# Hyannis Golf Course

## Town of Barnstable ADA Transition Plan

August 2021

Institute for Human Centered Design

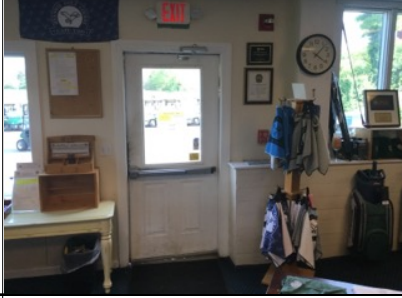
ID	Location	Floor	Room	Element	Type	Photo	Issues	Current Measure	Recommendations	Quantity	Price	Cost Estimation
<b>Approach and Entrance</b>												
<b>Exterior Access Route</b>												
1	Entrance to Pro Shop - Hyannis Golf Club	Ext		Exterior Access Route	Exterior		Obstructed by protruding objects Vertical clearance < 80" above ground	8" 64.2"	Relocate lamp so that the bottom of the lamp is 80" min. above the ground.	1	306	\$306
2	Route from Parking to Pro Shop	Ext		Exterior Access Route	Exterior		Cross slope > 1:50 (2.00%)	6.3%	Reduce cross slope to be no steeper than 1:50 (2.00%).  (Cost based on asphalt to correct slope.)	1	240	\$240
3	Pro Shop to Stairwell - Hyannis Golf Club	Ext		Exterior Access Route	Exterior		Cross slope > 1:50 (2.00%)	5.5%	Reduce cross slope at stair landing to be no steeper than 1:50 (2.00%) in all directions.  (Cost based on a 4' x 4' brick paver patch.)	1	416	\$416

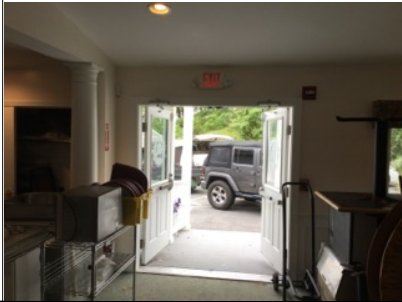
4	Entrance to Pro Shop - Hyannis Golf Club	Ext		Exterior Access Route	Exterior		Cross slope > 1:50 (2.00%) Running slope > 1:20 (5%)	2.9% 9.2%	Reduce slope at door landing to 1:50 (2.00%) in all directions.  (Cost based on asphalt to correct slope.)	1	240	\$240
5	Teeing Station	Ext.		Exterior Access Route	Exterior		Level changes > 1/4"	1"	Alter change in level to be 1/4" high max. (Ensure that at least 3 of the 55 driving range bays - 5% - are on an accessible route and have an entry with a change in level no greater than 14")  (Cost based on a concrete patch at 3 driving range bays.)	3	256	\$768

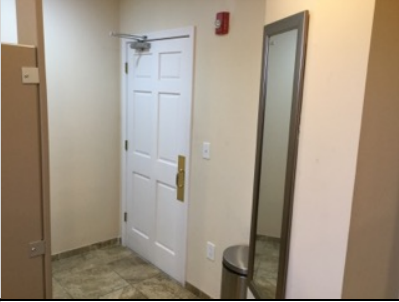
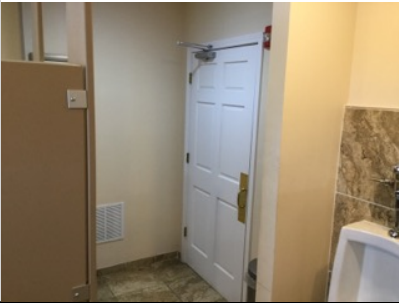
ID	Location	Floor	Room	Element	Type	Photo	Issues	Current Measure	Recommendations	Quantity	Price	Cost Estimation
16	Restaurant (Under Construction) - Hyannis Golf Club	2		Emergency Exit	N/A		Threshold > 1/2" high	1"	Alter the threshold to be 1/2" high max.	1	150	\$150
<b>Access to Goods and Services</b>												
<b>Means of Egress</b>												
17	Exit via Ramp to Parking Lot From Club House - Hyannis Golf Club	2		Means of Egress	N/A		Tactile exit sign not provided	-	Ensure tactile exit signs with raised characters and braille are provided at exit doors. Mount signs between 48"- 60" above the finished floor located on the latch side of the door.	1	232	\$232
18	Emergency Exit via Club House - Hyannis Golf Club	2		Means of Egress	N/A		Tactile exit sign not provided	-	Ensure tactile exit signs with raised characters and braille are provided at exit doors. Mount signs between 48"- 60" above the finished floor located on the latch side of the door.	1	232	\$232

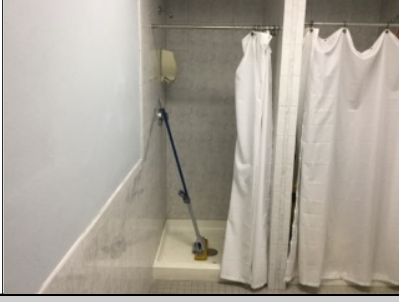
ID	Location	Floor	Room	Element	Type	Photo	Issues	Current Measure	Recommendations	Quantity	Price	Cost Estimation
40	Men's Toilet Room	1		Overall Access	183		International Symbol of Acc. not provided	- -	Provide a sign with the International Symbol of Accessibility mounted on the latch side of the door once issues with the door, toilet room and shower are made accessible.	1	232	\$232
<b>Lavatory</b>												
41	Women's Toilet Room	1		Lavatory	N/A		Toe or knee clearances not provided Plumbing underneath is exposed	- -	Provide at least one lavatory with knee and toe clearance positioned for a forward approach. Insulate or otherwise configure pipes to prevent contact for at least one lavatory.	1	1778	\$1778
42	Men's Toilet Room	1		Lavatory	N/A		Toe or knee clearances not provided Mirror above lavatory w/reflective surface > 40"	- 43.7"	Provide at least one lavatory with knee and toe clearance positioned for a forward approach. Lower mirror so that the bottom surface is at 40" max. above the finished floor.	1	1942	\$1942
